RE: IDC Triennial Review – Easement and Access Concerns

1.0 EASEMENTS OVER PIPE INFRASTRUCTURE

Figure 1: Example of TCC requiring wide easements over infrastructure. The wastewater main running within easements E, F, and G at the right of the image is approximately 2m deep and 1.0m off the boundary. TCC have insisted on the provision of a 4m wide easement, as shown.

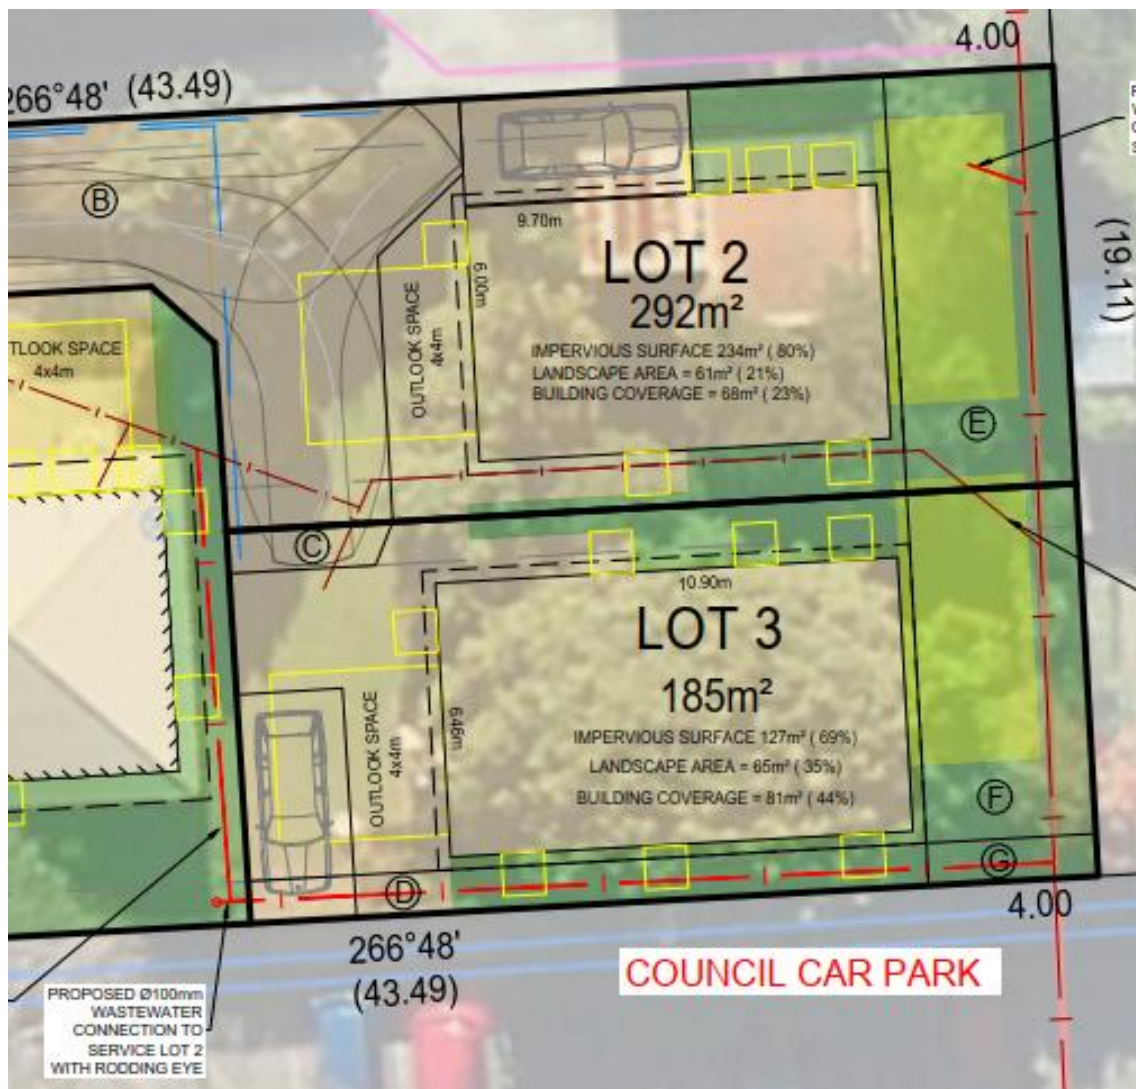
The wastewater pipe at the right of Figure 1 is approximately 2m deep, and approximately 1m from the existing site boundary. TCC insisted on the 4m wide easement shown in the figure, significantly compromising the available land to build on. If a subdivision or land use consent hadn't been required, a dwelling could have been built 1m from the outside of the pipe under the building code, and easements would not have been demanded. If a dwelling were to be constructed 1.5m from the pipe, an easement of 2.5m wide could be created. That would be sufficient to allow a contractor to operate safely on any necessary maintenance or replacement works.

Council considered reducing the width slightly, but required the entire section of pipe between manholes to be relined. In this (and most other cases) instance, the manholes are located in other private properties, so consent is required from the owners of the adjacent properties. This is not likely to be forthcoming, and often times landowners demand compensation. Relining the pipe is also costly in terms of both time and money.

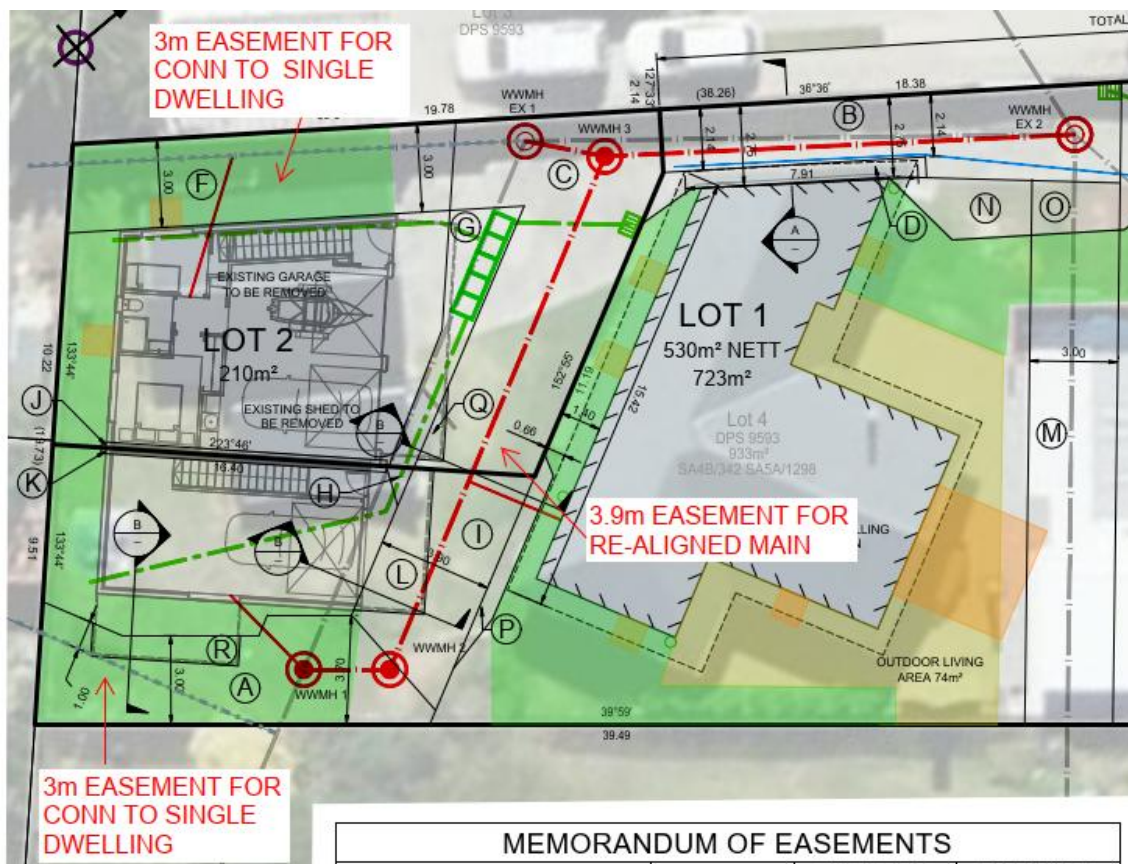
There are private connections to single properties in easements F and A/R (at the top and bottom left of Figure 2, respectively). In both cases the pipes are only 1.0-1.5m deep. Council have requested 3.0m wide easements over both. There is no practical need for those easements to be so wide, and TCC's insistence on them has forced this development to reduce the lot count from three to two.
